City of  
Richmond

Report to Development Permit Panel

**File:** DP 12-624819

**Re:** Application by Matthew Cheng Architect Inc. for a Development Permit at 8200,  
8220, 8280 and 8300 No. 1 Road

Sheet Title:  
**ROOF PLAN**

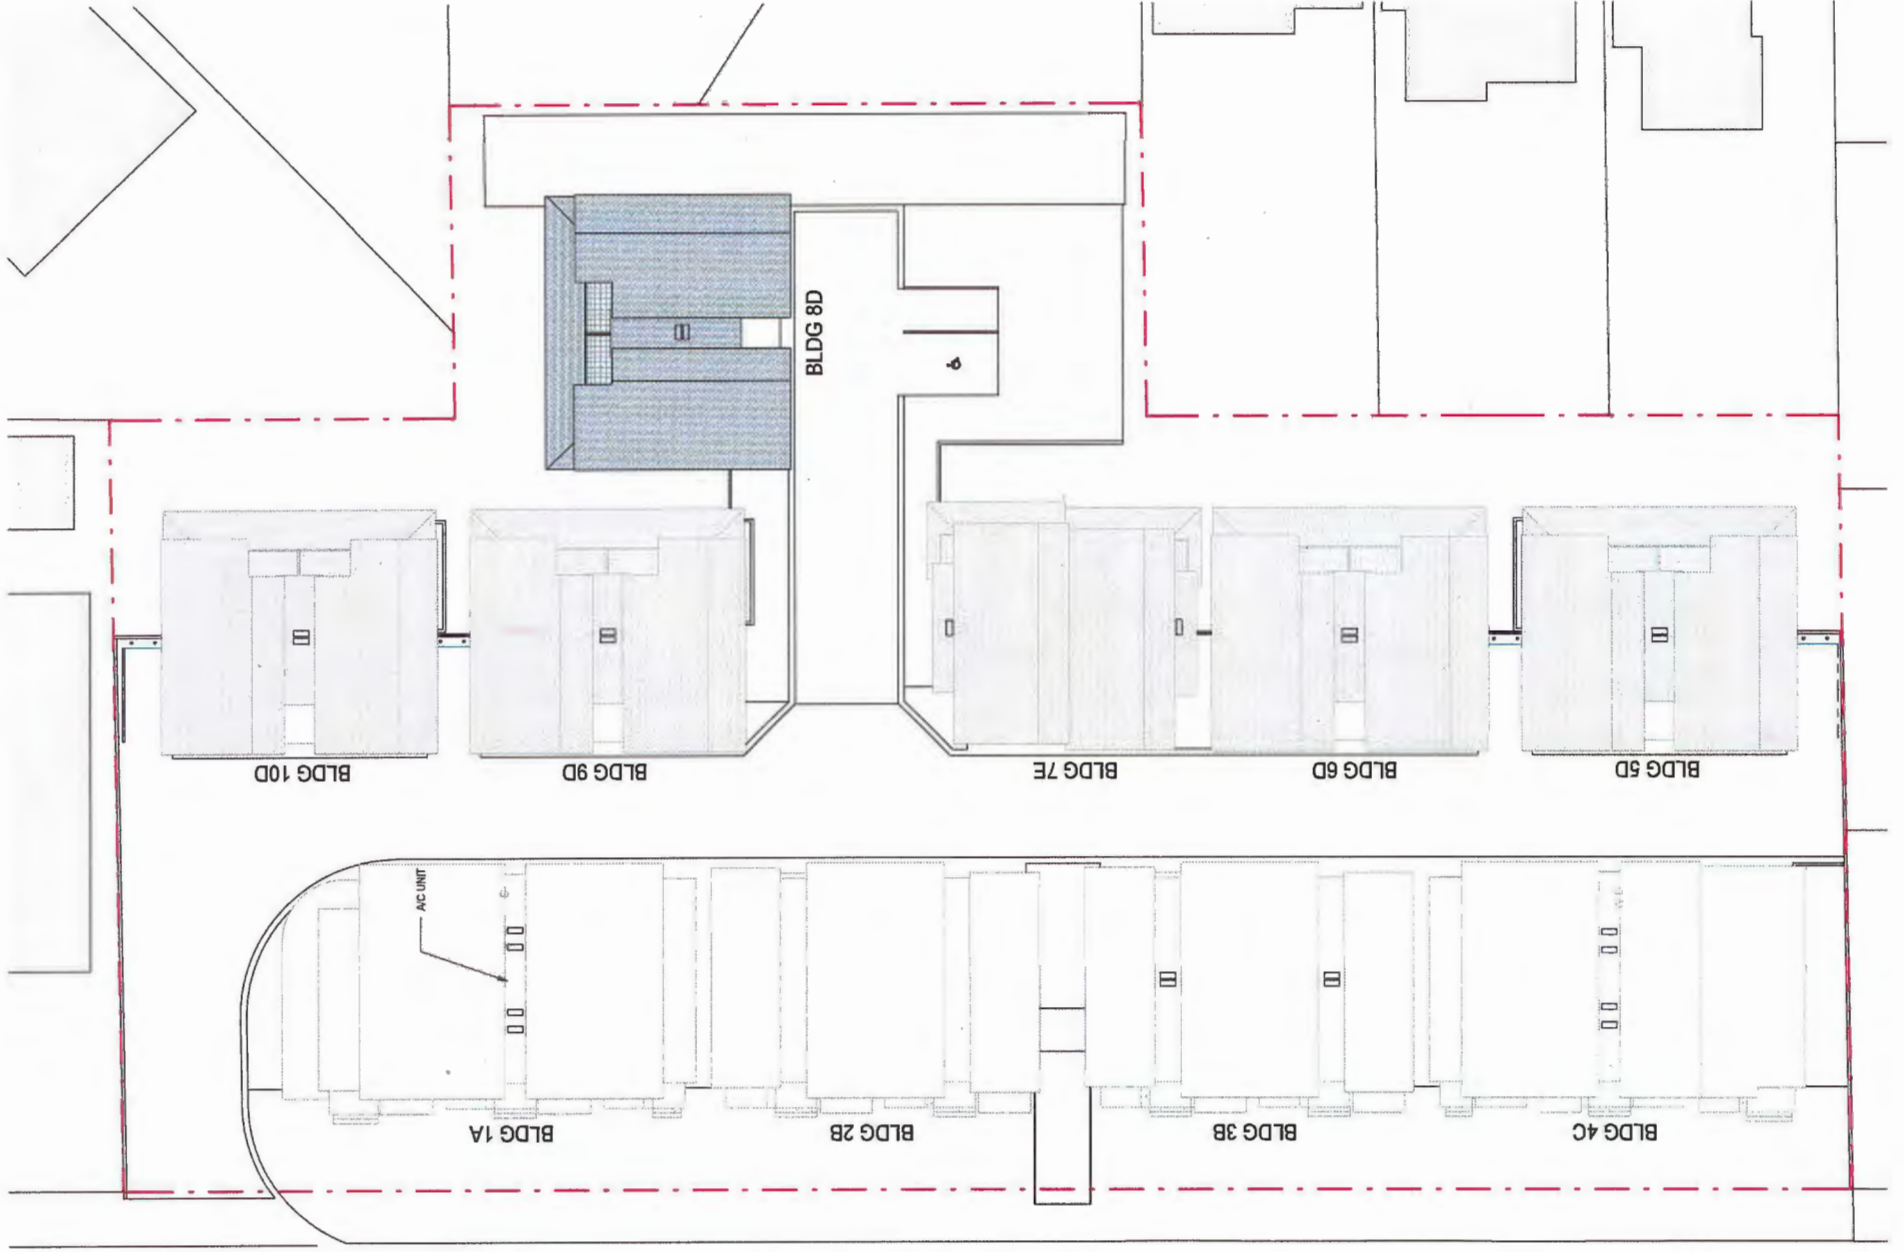
- concerned with the mechanical units being visible in the yards; and *the plan calls for plantings at the front part of the areas between units to screen where mechanical units area placed. (mechanical units will be placed on roof tops or balconies and hidden from view)*

Sheet Title  
**BLDG E -**  
**CONVERTIBLE**  
**UNIT**

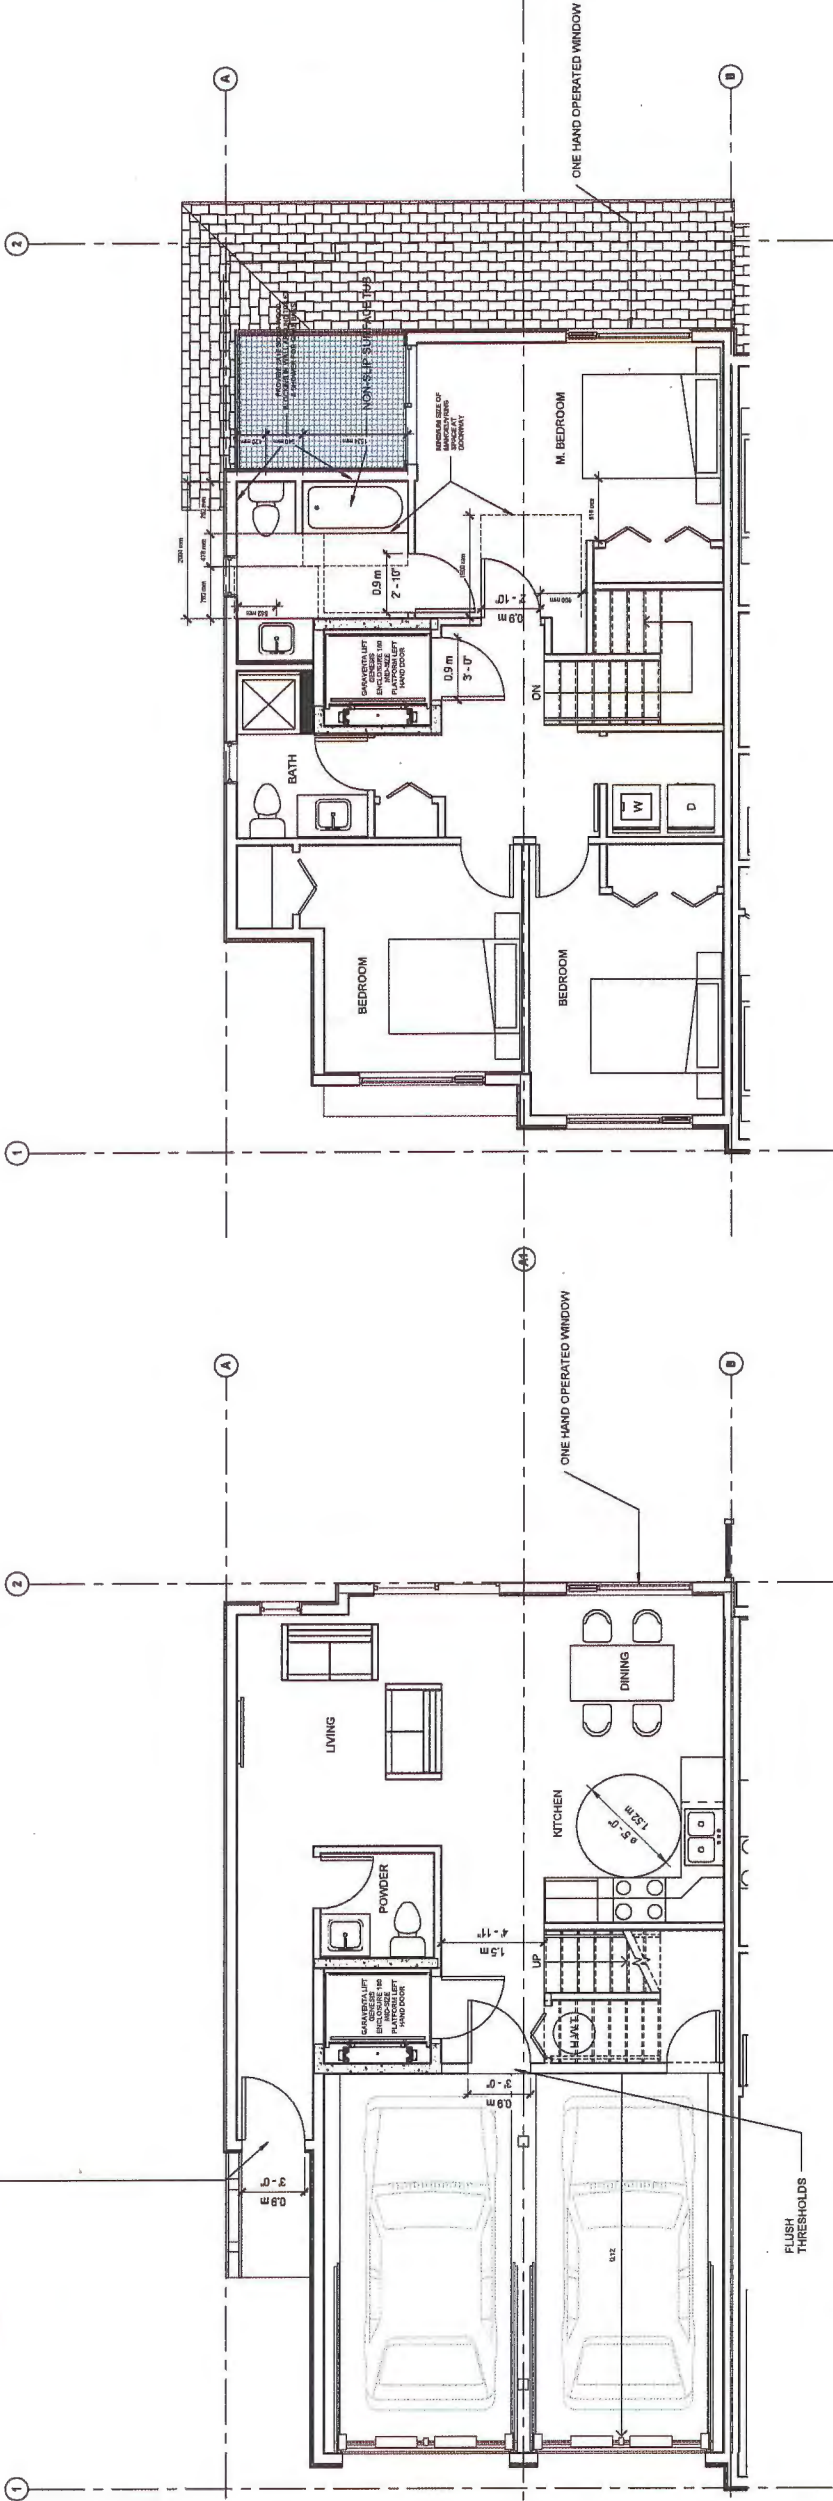
- appreciate the provision of a convertible unit; however, there are opportunities for improvement; identify a suitable space in the garage for future location of a vertical lift as opposed to the ground floor hallway; also consider reorienting the washrooms and bedrooms on level 2 to provide more workable entries; also consider introducing pocket doors in lieu of swinging doors; *\*\*PROVIDED – Door of the Vertical Lift is provided to conveniently access coming out of the Garage.*
